### **Discretionary Review Abbreviated Analysis** HEARING DATE: FEBRUARY 20, 2020

Date:	February 10, 2020
Case No.:	2018-007763DRP-06
Project Address:	66 Mountain Spring Avenue
Permit Application:	2018.0517.9469
Zoning:	RH-1 (D) [Residential House, One-Family- Detached]
	40-X Height and Bulk District
Block/Lot:	2706 / 025
Project Sponsor:	Amir Afifi
	Sia Consulting Corp.
	1256 Howard Street
	San Francisco, CA 94103
Staff Contact:	David Winslow – (415) 575-9159
	David.Winslow@sfgov.org
Recommendation:	Do Not Take DR and Approve

### Exhibit 10: Page A-1.1 311 Notification

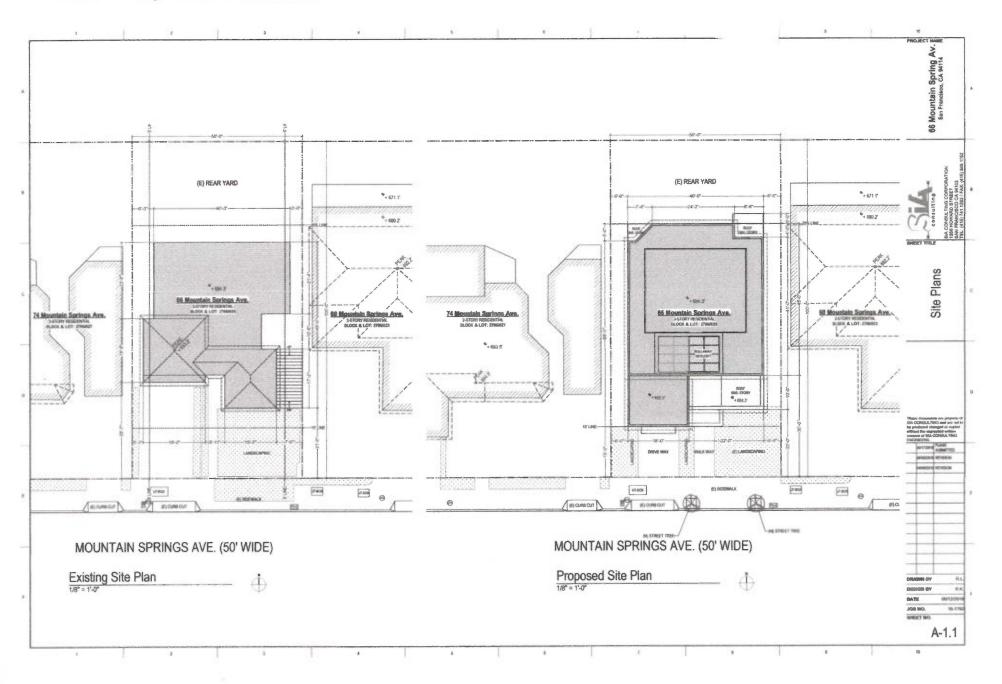
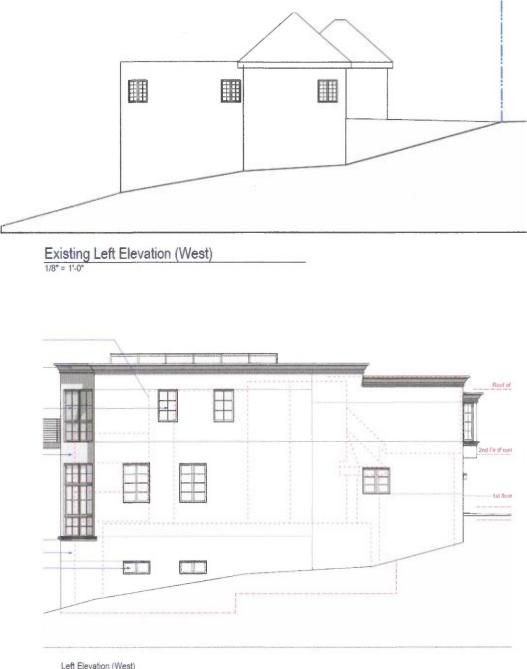
There is also an inaccurate height disclosure in the 311 Notification and in the plans themselves. The height of the existing building is listed in the 311 Notification as twenty fee and one inch (20'1") and the claimed proposed height of the new building is to be only eleven inches (11") taller at twenty-one feet (21'). However, the existing building is NOT 20 feet tall as measured under the Planning Code (or common sense).

Figure 3: Shadow & Rear Mass Comparison of *Existing* vs. *Proposed* Properties (Sunrise, *March 21)*

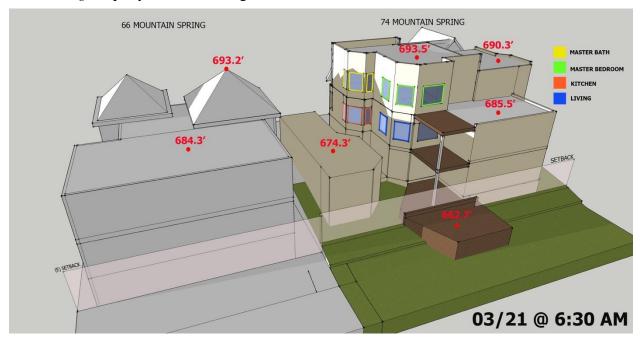
3a: *Existing* Property – allows sunlight into master bedroom and bathroom at sunrise

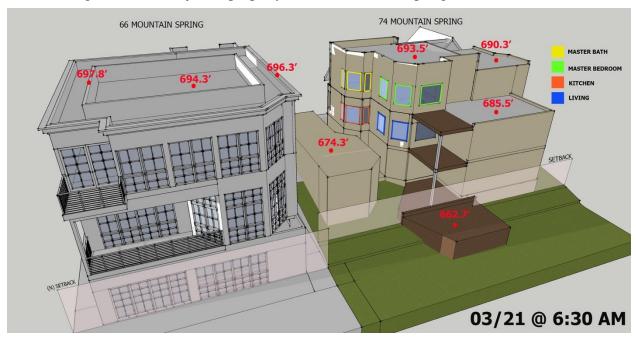
**3b:** <u>*Proposed*</u> Property – **blocks** sunlight into master bedroom and bathroom at sunrise. Rear mass too large relative to adjacent property to at 74 Mountain Spring Avenue

#### Figure 4: Shadow Comparison of *Existing* vs. *Proposed* Property at Sunrise on *June 21*

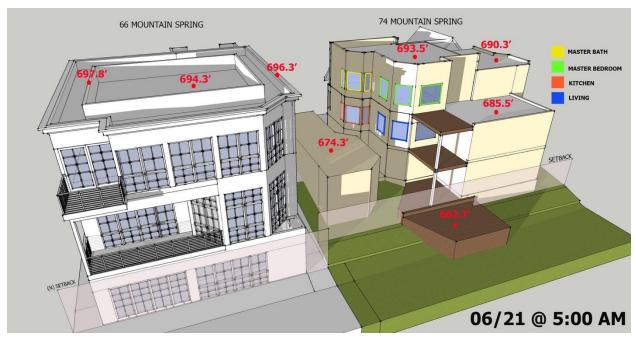
**4b:** <u>*Proposed*</u> Property – blocks sunlight into master bedroom and bathroom at sunrise. Rear mass too large relative to adjacent property at 74 Mountain Spring Avenue

Figure 5: Shadow Comparison of *Existing* vs. *Proposed* Property at Sunrise on *September 21*

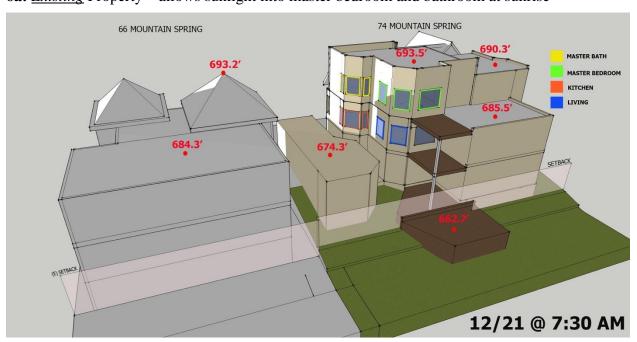
**5b:** <u>*Proposed*</u> Property – blocks sunlight into master bedroom and bathroom at sunrise. Rear mass too large relative to adjacent property at 74 Mountain Spring Avenue
